Stitchtone Apparels Ltd. (9884)

18/19, Strand Road, Champa Tower

Identified Priority 1 Concerns

5th floor roof slab

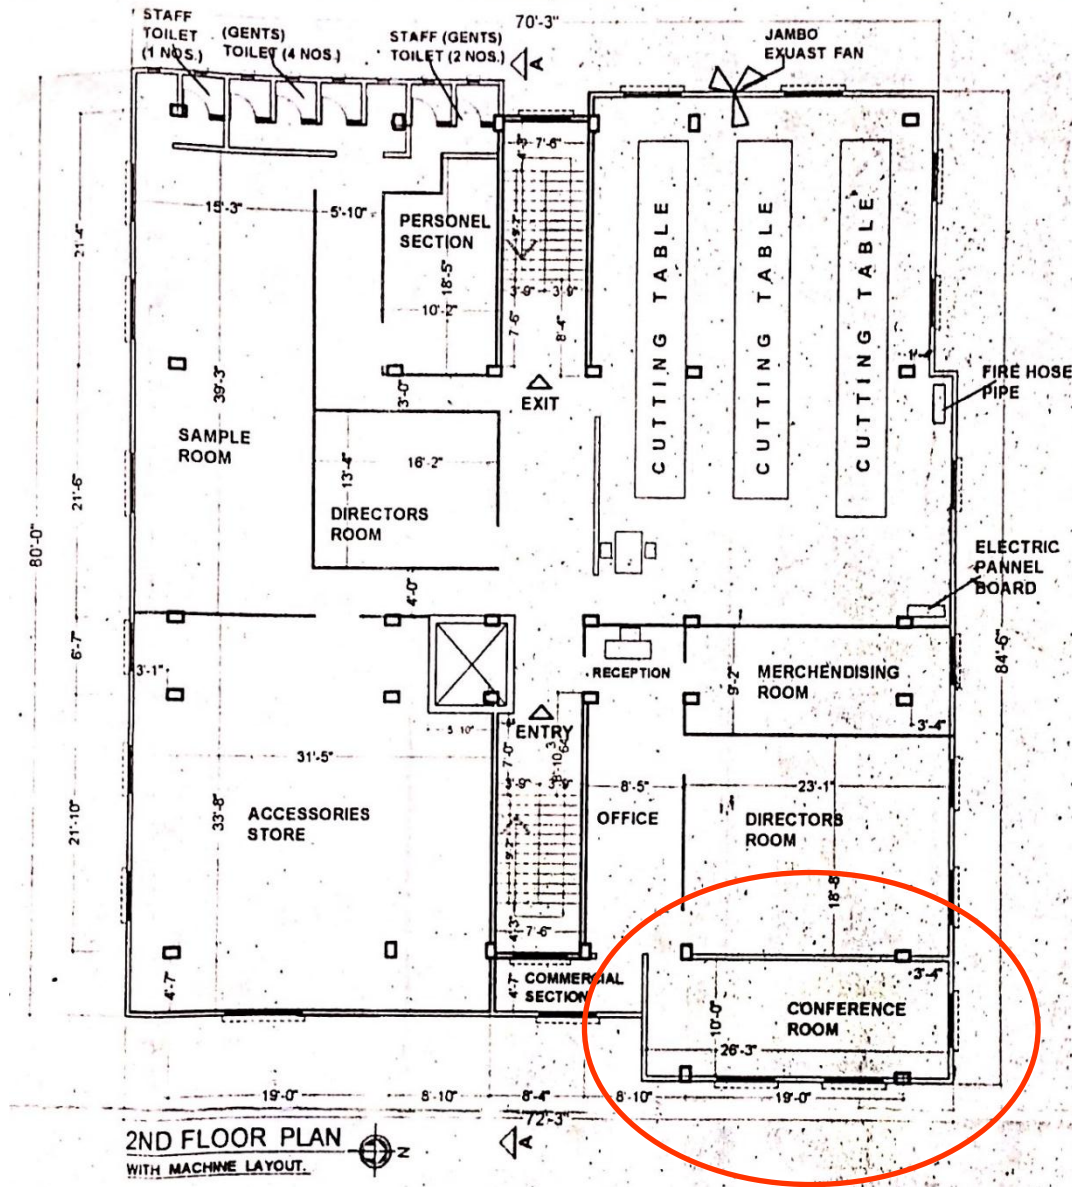
The columns are overstressed due to additional live loading and steel roof on roof slab (5th floor).

Item No.	Observation	Recommended Action Plan	Recommended Timeline
1	The columns are overstressed due to additional live loading and steel roof on roof slab (5th floor).	Do not increase the loading and follow posted loading plans. A Detail Engineering Assessment of Factory to be commenced, see attached Scope.	immediate – now
2	The columns are overstressed due to additional live loading and steel roof on roof slab (5th floor).	Complete the Detailed Engineering Assessment for the load bearing capacity of concrete columns. Verify concrete strength by 100mm dia. Cores – see DEA scope.	6-weeks
3	The columns are overstressed due to additional live loading and steel roof on roof slab (5th floor).	Implement recommendations from DEA.	6-months
4	Structural drawings do not match as built conditions and are incomplete.	Structural Engineer responsible for design to revise drawings to match existing condition. Detailed Engineering Assessment is required for extension, cantilevered slab, and steel roof.	6-weeks
